STATEMENT OF CHANGES SECTION 57A SUBMISSION

Planning Permit Application No. PLN17/0398 - 66 Cecil Street, Fitzroy

3 TOWNHOUSES 66 Cecil St, Fitzroy VIC 3065

City of Yarra Heritage Advice

TP004 - EXISTING & PROPOSED STREETSCAPE ELEVATIONS

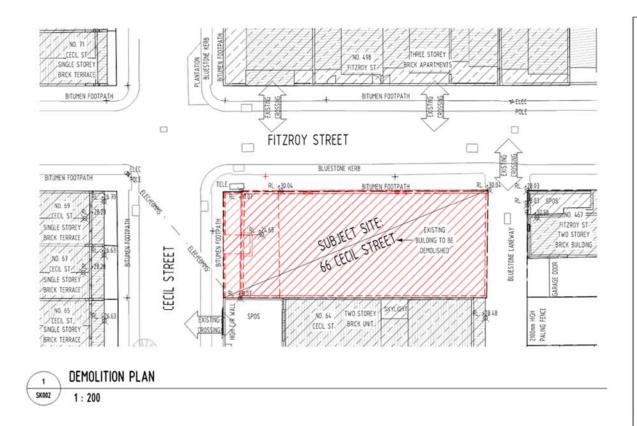
- Area schedule has changed to reflect the reduction in the number of townhouses from 4 to 3
- 6. Reduction in overall height by one level.
- Extent of brickwork, metal cladding and window configuration has been amended to suit the modified design.

Above: Comparative scale of surrounding area.

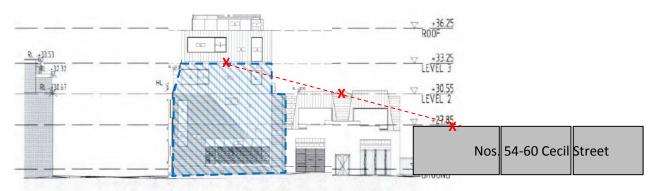
The common street facade height of the adjacent non-contributory buildings in the street is therefore 6.1 metres which is consistent with the first two floor levels of the proposed development.

Although the proposed Levels 2, 3 and the roof terraces of the new development are slightly set back, the building will still clearly read as an almost sheer perimeter wall of about 13 metres in height. Being a corner site means that these 13 metre walls will be fully exposed to two street frontages as well as being visible from all four approaches towards the intersection. Within the Cecil Street streetscape, the height of the proposed façade will be twice as tall as the immediately adjoining townhouses (nos. 62 and 64) and will be a dramatic contrast in scale to the nearby single-storey dwellings of contributory significance.

Using the finished height of nos. 62 and 64 for a mid-way transitional purposes, it is considered that the maximum height of the proposed development fronting Cecil Street should be no greater than three storeys (or about 10 metres), with the uppermost floor level clearly setback from the street façade. With a reduced finished RL level of about 33.5, the scale of the proposed building will be in keeping with the established height of no. 494 Fitzroy Street.
